# Work Order ID 69959

Item Name: Crösstube Aft

DART AEROSPACE LTD		Work Order:	69959
Description: Crosstube High Aft (407)		Part Number:	D407-667-205
Inspection Dwg: D407-667-245 Rev: F		Page 1 of 1

DRAWING NO. D407-667-245	TITLE CROSSTUBE ASSY (407 HIGH AFT)	REV. F	DART AEROSPACE LTD ENGINEERING ORDER		D.E.O. NO. D407-667-245-F-1	SHEET NO. SHEET 1 OF 2	SCALE NTS
DRAWN J	CHECKED 47	MFG. APPR. E	APPROVED 140		DE APPR. H		
DATE 11.04.08	DATE 11.04.12	DATE 11.04.12	DATE 11.04.12		DATE 11.04.12

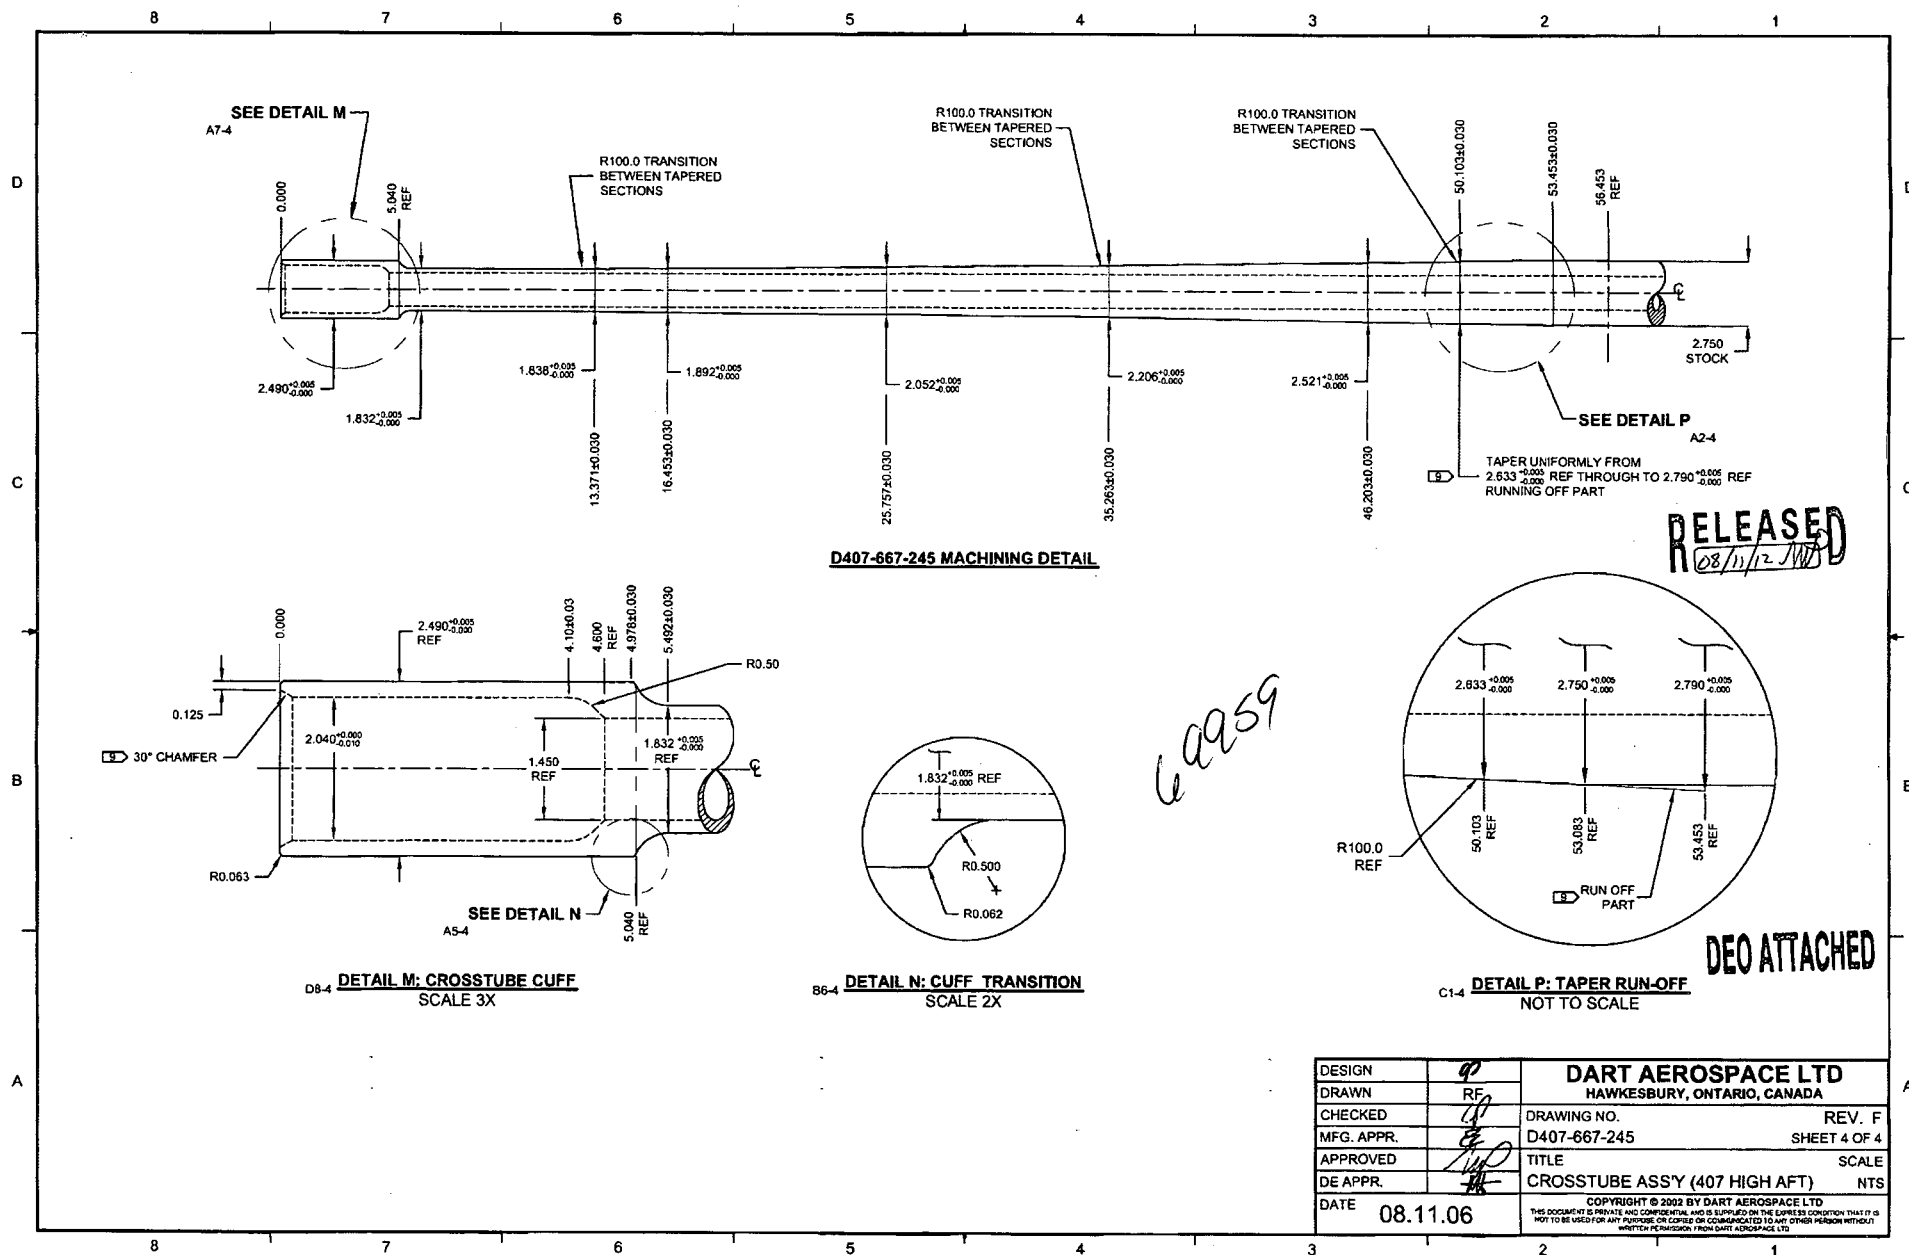
NOTES 2 AND 15, SHEET 1 ARE AMENDED AS FOLLOWS:

- 2) FINISH: CHEMICAL CONVERSION COAT PER DART QSI 005 4.1  
PRIME INSIDE AND OUTSIDE PER DART QSI 005 4.2  
MASK UNDERSIDE OF CROSSTUBE AS SHOWN (HATCHED AREA) AND  
PAINT OUTSIDE PER DART QSI 005 4.2  
REMOVE MASKING AND APPLY CLEAR COAT
- 15) APPLY A THIN COAT OF PROSEAL 890 ON INSIDE CONCAVE SURFACE OF D3190-1  
CHAFING SHIELDS AND LET CURE PER MANUFACTURER'S INSTRUCTIONS. INSTALL  
PROSEALED D3190-1 CHAFING SHIELDS ONTO CROSSTUBE BY APPLYING A THIN COAT  
OF PROSEAL 890 ONTO CROSSTUBE. BE SURE TO ELIMINATE ANY AIR GAPS.

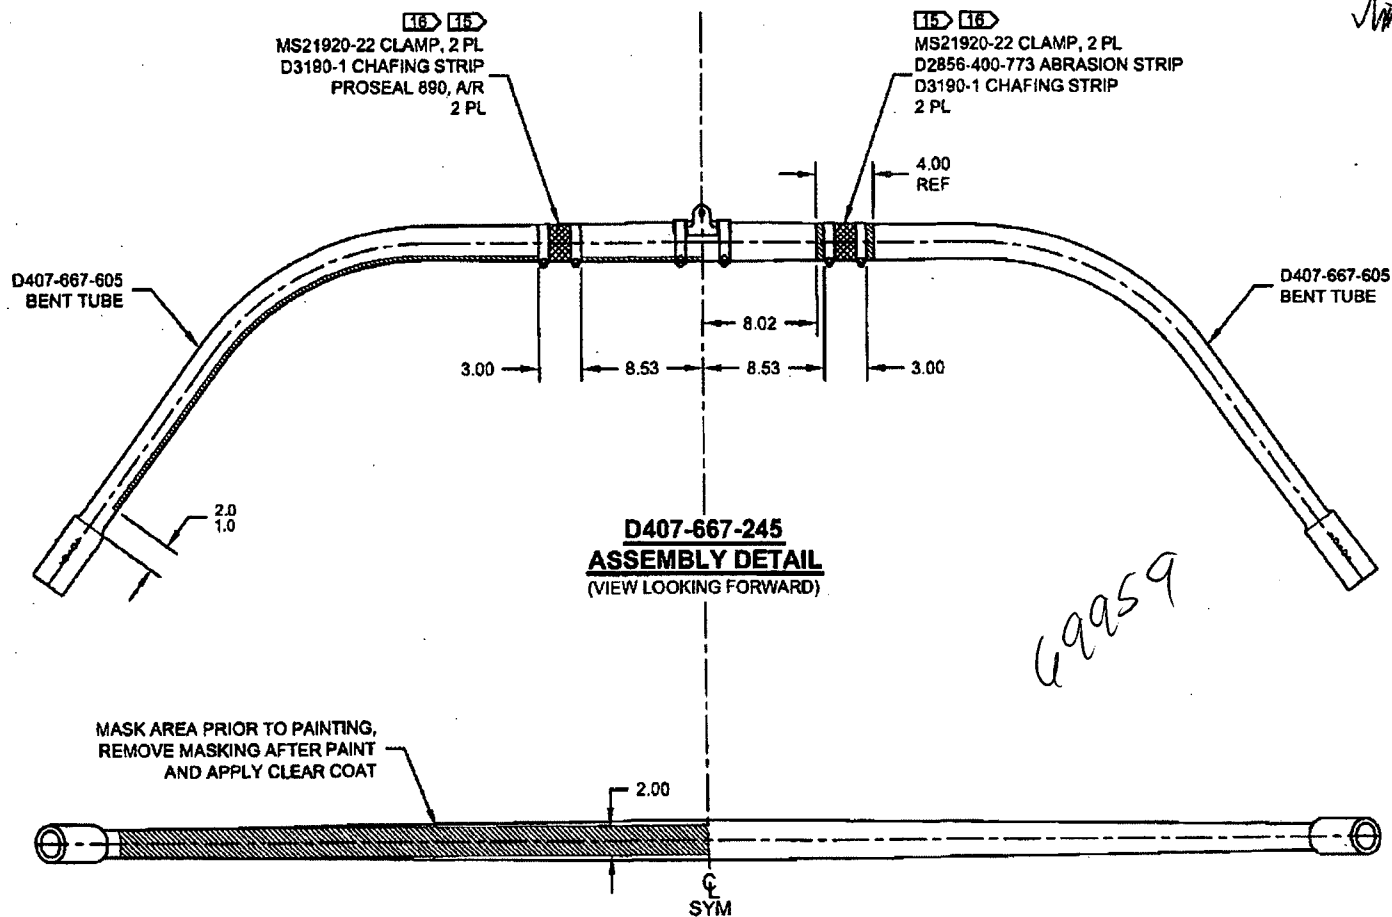
IS:
